ADDENDUM NO. 4

Dated: June 23, 2016

LAFAYETTE BOULEVARD STREETSCAPE IMPROVEMENTS

SHEET LP-9.0- LANDSCAPE PLAN

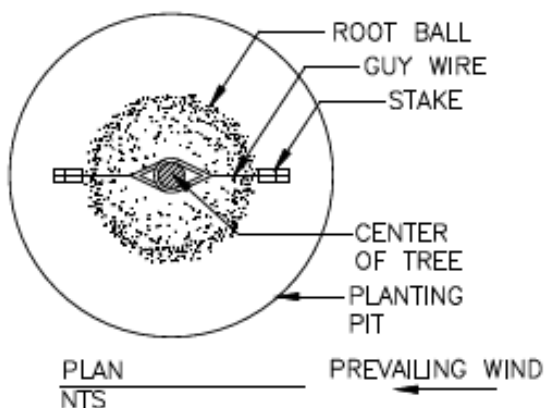
Remove: CITY OF NORFOLK LANDSCAPE NOTES, Note #4.

Remove: TYPICAL TREE PLANTING DETAIL in its entirety.

Add: TYPICAL TREE PLANTING DETAIL from this Addendum.

TYPICAL TREE PLANTING DETAIL

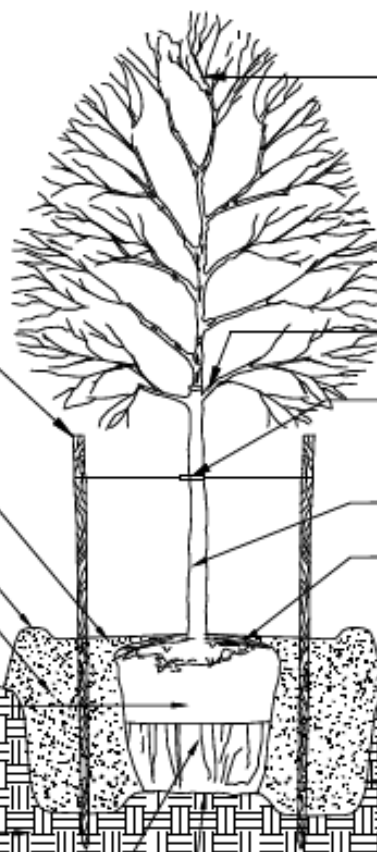
~~SPECIFIED PLANTING~~ EXISTING SOIL

BACKFILL WILL BE
SPECIFIED PLANTING SOIL
